DALHOUSIE COMMUNITY ASSOCIATION

1 February 2026

We have the following concerns and objections to this latest proposal.

601 LAURIER AVENUE TRANSITION / ANGULAR PLANE STUDY CORRECTED
 | 2318 | SCALE N.T.S.

Illustration #2

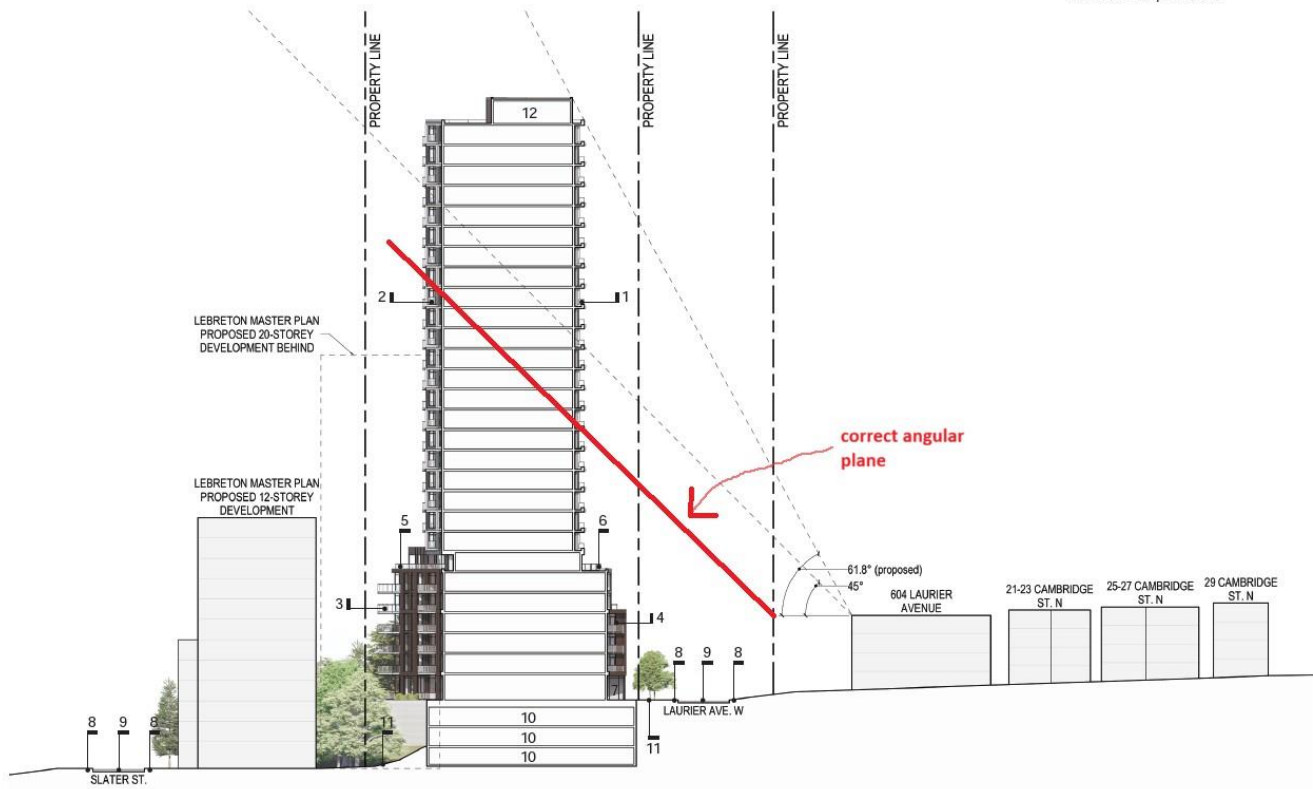
C. The proposed **“angular plane”** of 62 degrees from the house front at 604 Laurier is **grossly at variance with the by-law norms!**

1. Such a plane is typically measured, not from the enormously setback existing house, but from the front lot line. Future low-rise development at 604 would otherwise be adversely affected.

2. The usual 45 degree plane should be enforced.
